DEMO-CEO Van der Waalsweg 8 2628 CH Delft		
Title 2uD FFC50 vertical		
Size A4	Document Number 18-019	Rev 1.0
Date: Monday, October 21, 2019		
Sheet 1 of 1		1

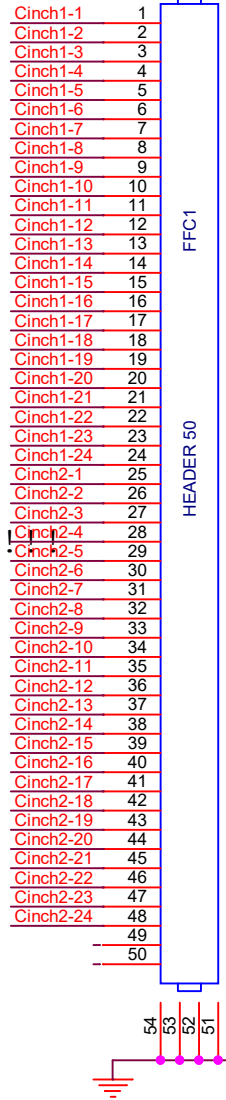
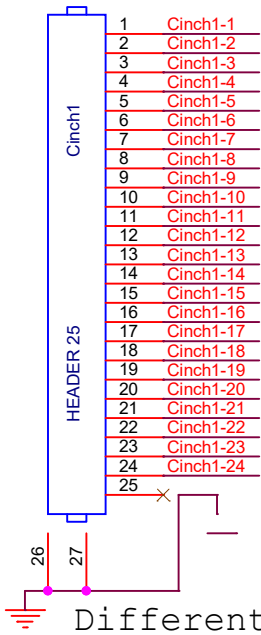
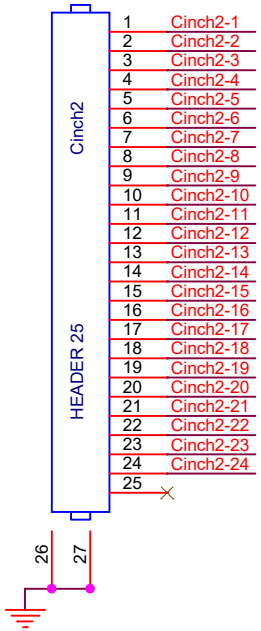
Different numbering uD !!!

Mind import in PCB editor, as component is flipped

Different numbering uD

Cinch 1 pin 1-24 connected to FFC 1-24
Cinch 2 pin 1-24 connected to FFC 25-48
